FAQ Number 13-0002 FAQ Revision 01k

FAQ Title Modeling of Main Control Room Abandonment on Loss of Habitability

Plant: Various Date: ~~21 May 2013~~ July 2013

Purpose of FAQ:

Figure 1 - Flow Chart for Abandonment Due to Loss of Habitability (LOH)

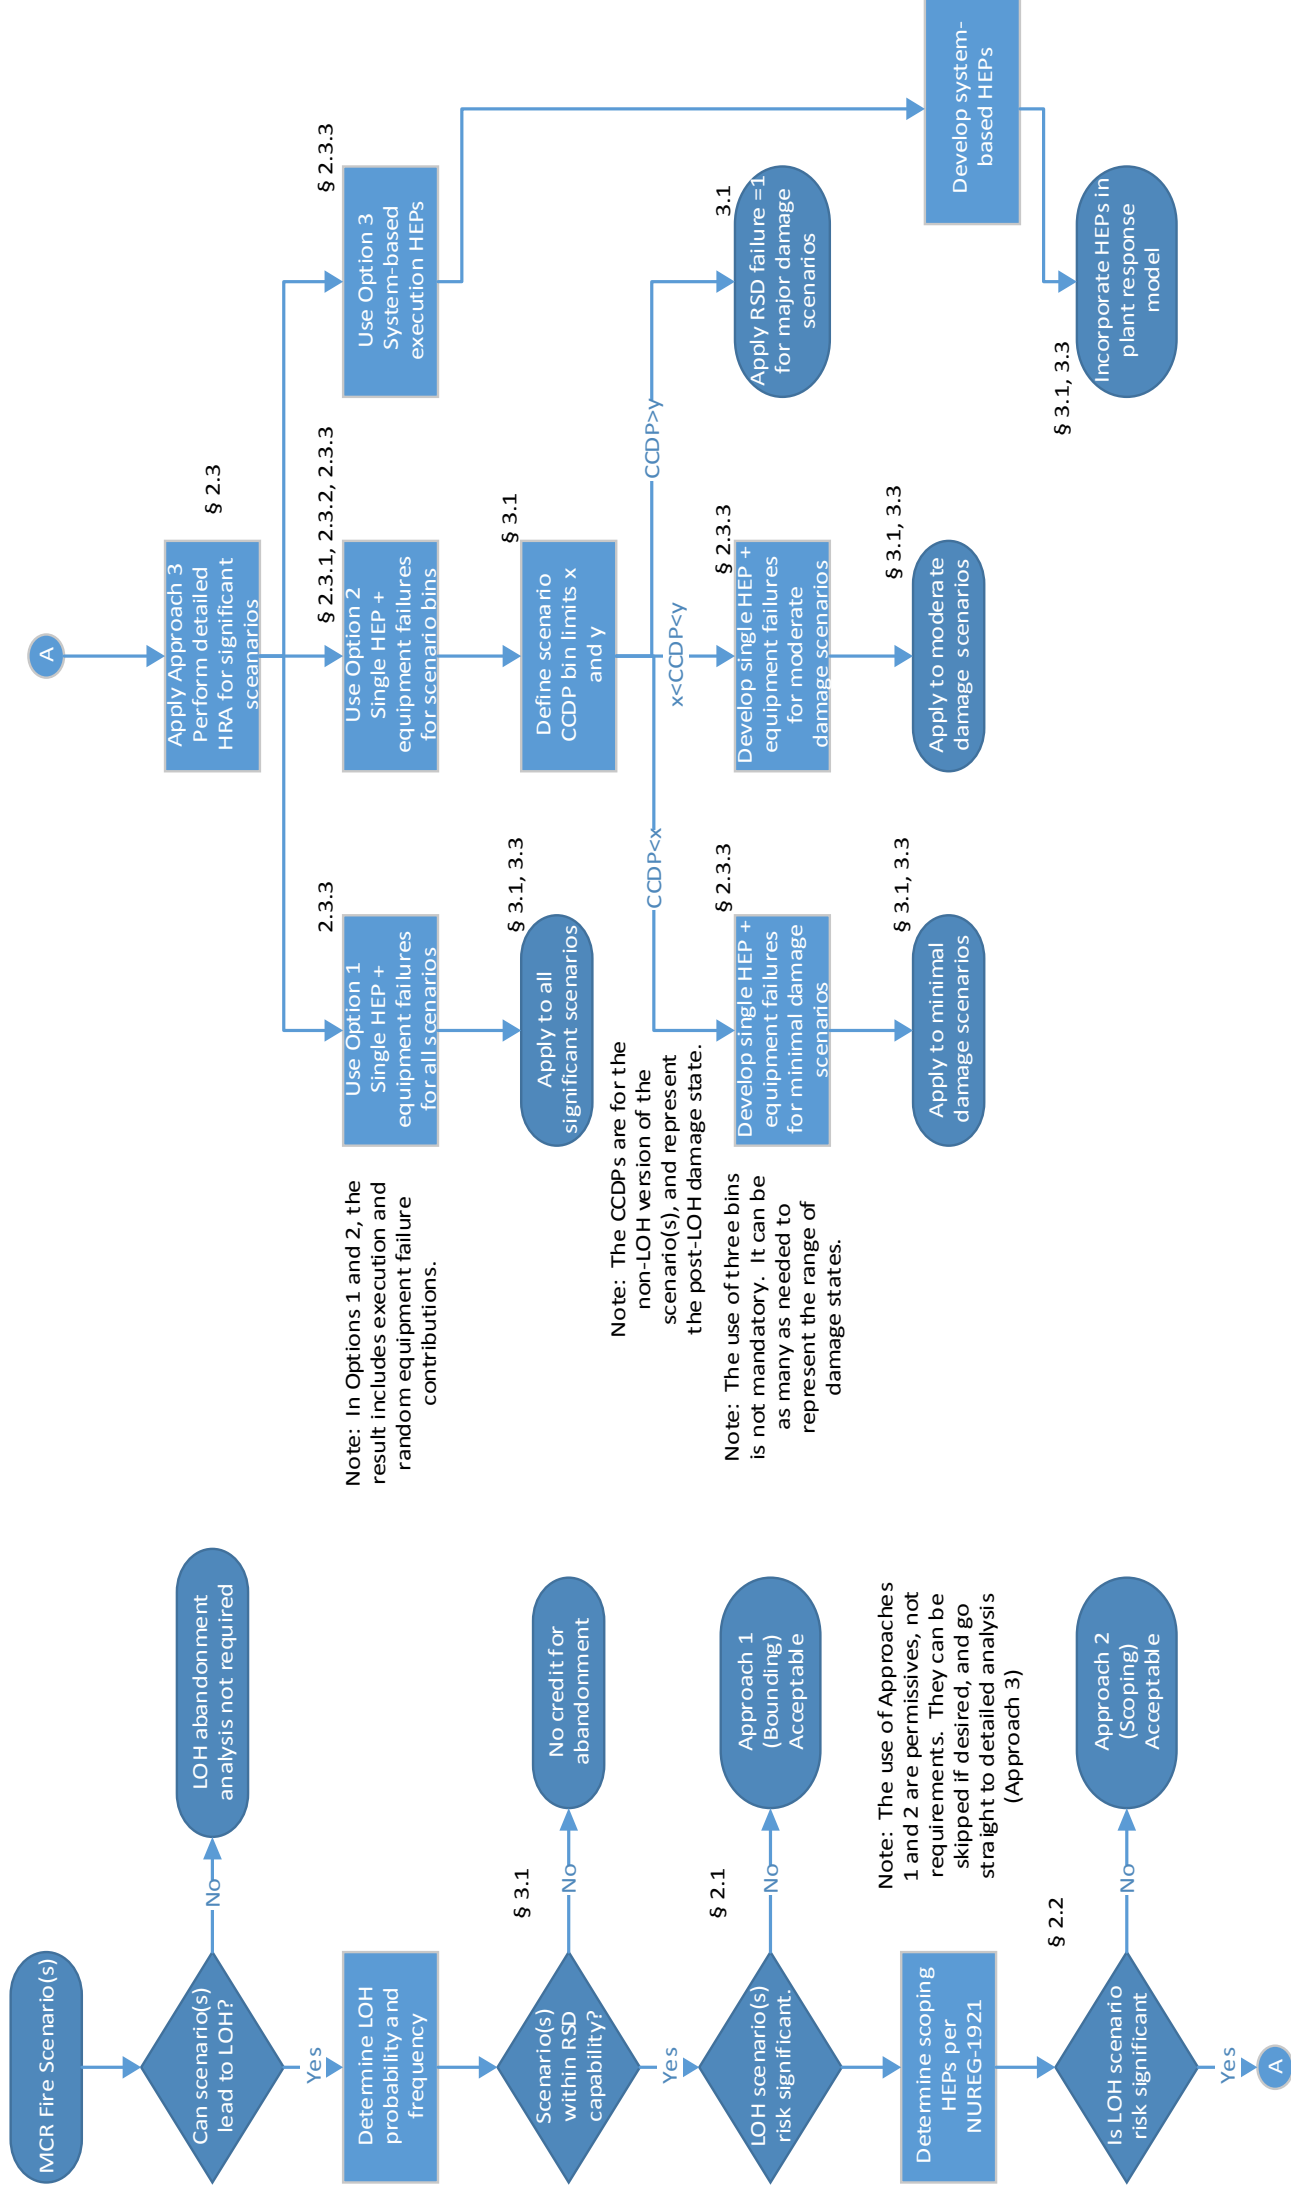
Appropriate modeling for each of these is outlined in Figures ~~1 and 2~~. The process steps in the flow charts are described in the text below, which describe the various approaches and options. The “approaches” address differences in the human reliability analysis modeling, and the “options” describe different ways to incorporate the resulting human failure event into the Fire PRA model. ~~There is a separate flow chart for the loss of habitability (LOH) and loss of control (LOC) cases because there are some fundamental differences in the details of the application of the HRA modeling approaches. However, there are some aspects of the approaches that are~~
